BC 450-05 Dundee Rec. & Parks Trail-
Site Plan & Canoe Launch

Re: Marshy Point Park – Pedestrian/Bicycle Trail

STAFF REPORT

PROPOSAL: Marshy Point Park - Pedestrian/Bicycle Trail

CONTRACT NO.	060980X0
JOB ORDER NO.	212.313.0012
SHEET 3 OF 26	
FILE	C-2

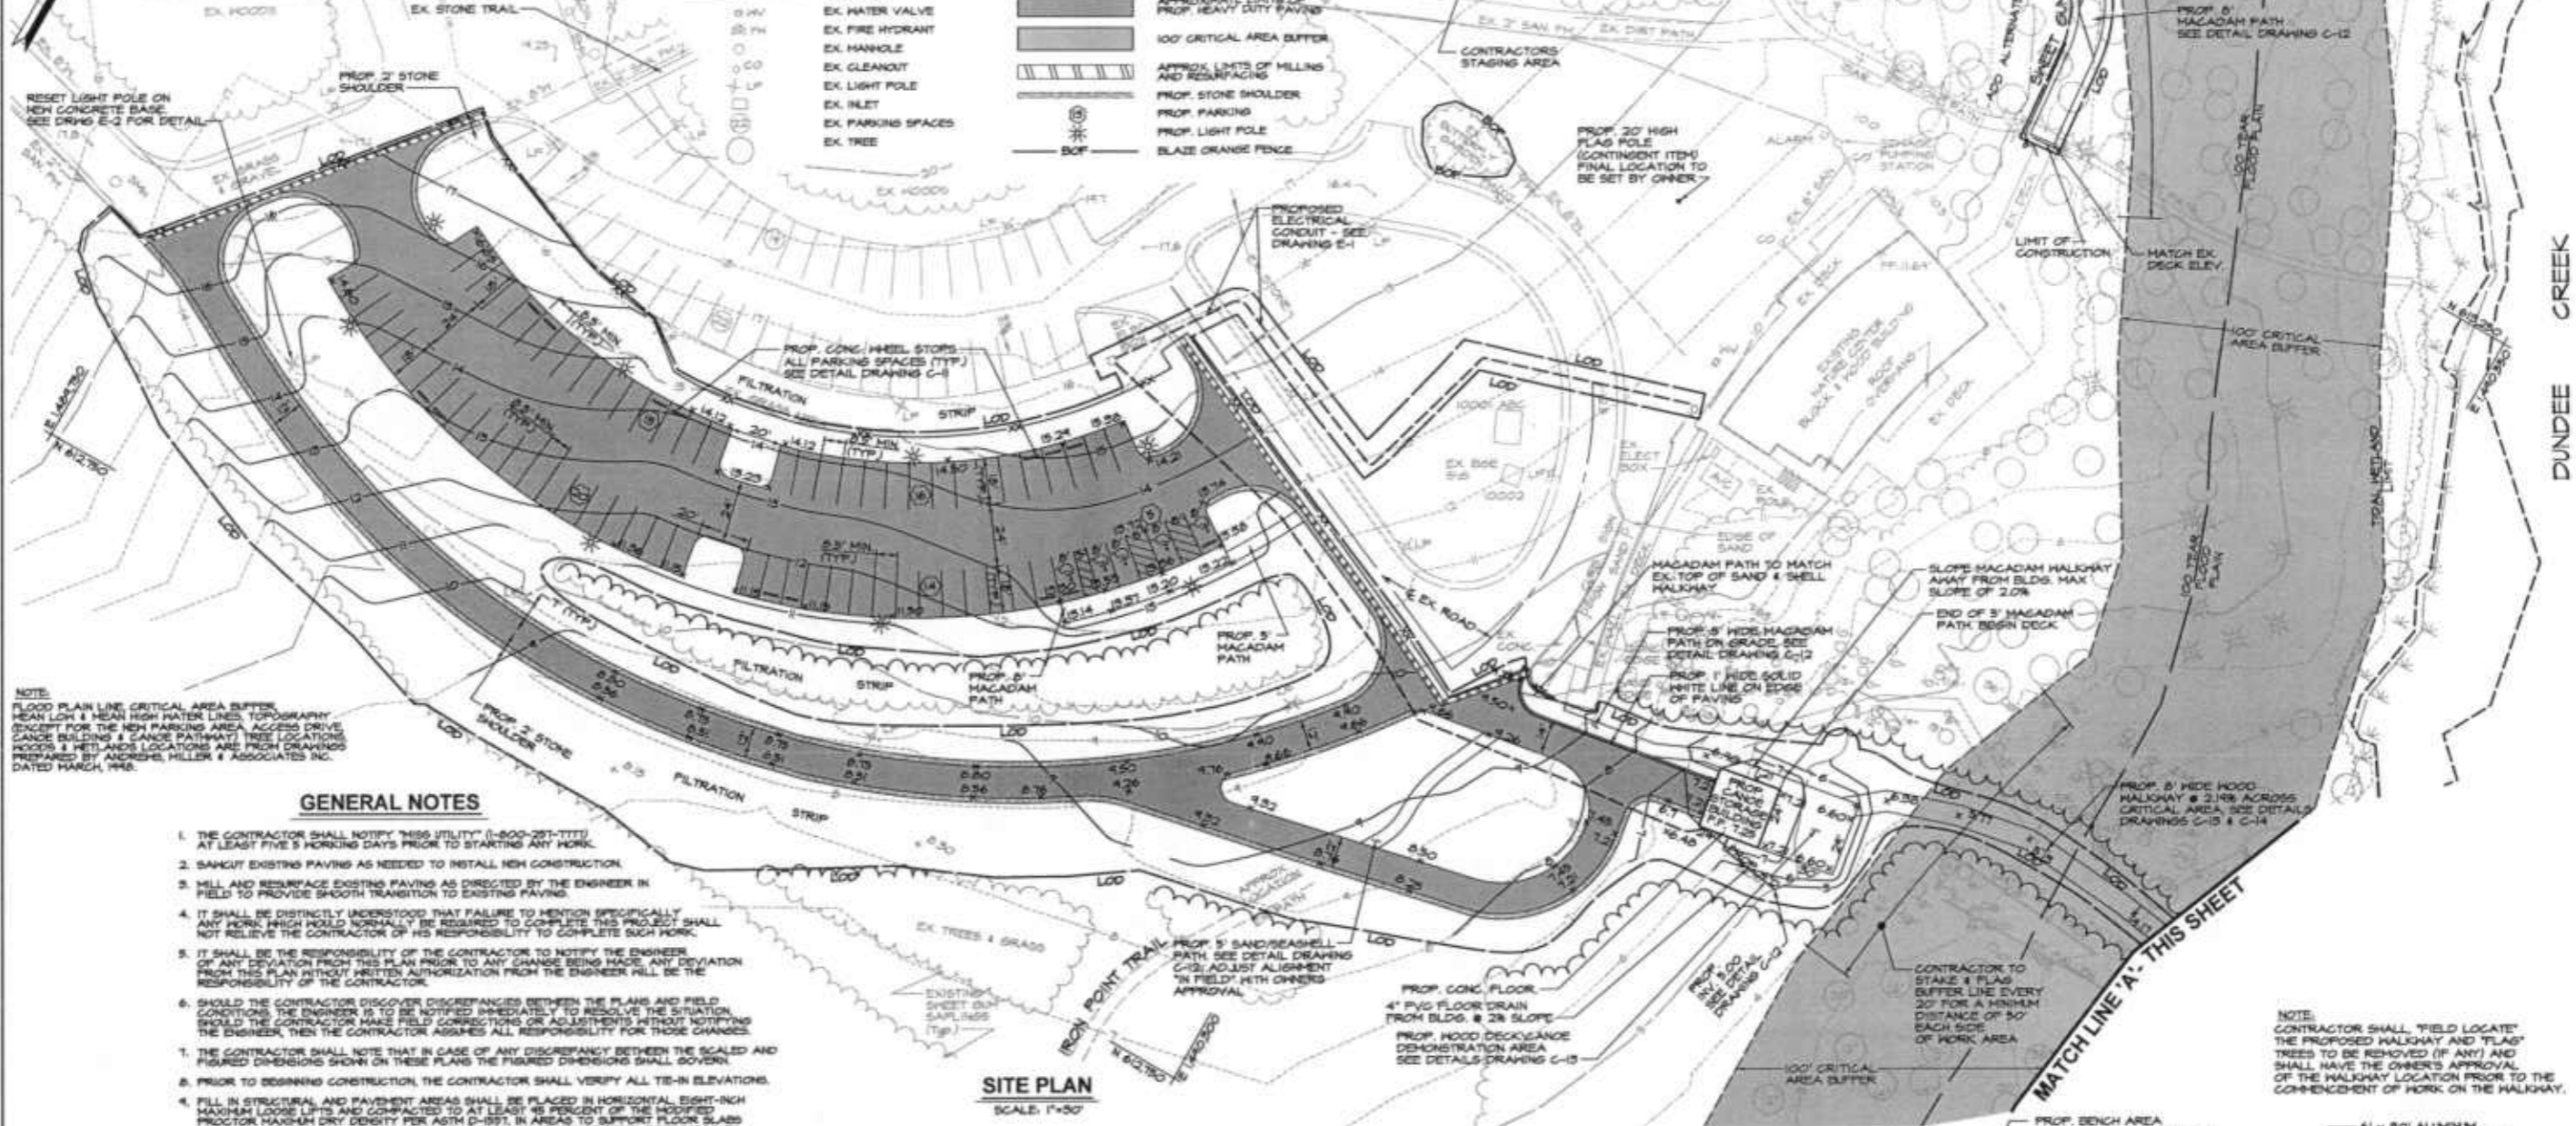
- 1) Mitigation shall be provided at a 2:1 ratio for the canoe launch portion of the trail inside the 100-foot Buffer, at a 3:1 ratio for the observation and bridge portions of the trail that will cross the 100-foot Buffer and be in FID habitat, and 1:1 mitigation for the portion of the trail in FID habitat, but outside the 100-foot Buffer.
- 2) The County shall follow the time of year restrictions for Forest Interior Dwelling Bird habitat; therefore, the clearing activities may not occur between April 15 and August 31.
- 3) All required permits are secured prior to construction.
- 4) If the plans change, the project must be resubmitted to the Commission staff for review.
- 5) All other trails inside the Critical Area, excluding the pedestrian/bicycle trail, that may be planned for this site shall be pervious and not exceed six feet in width.
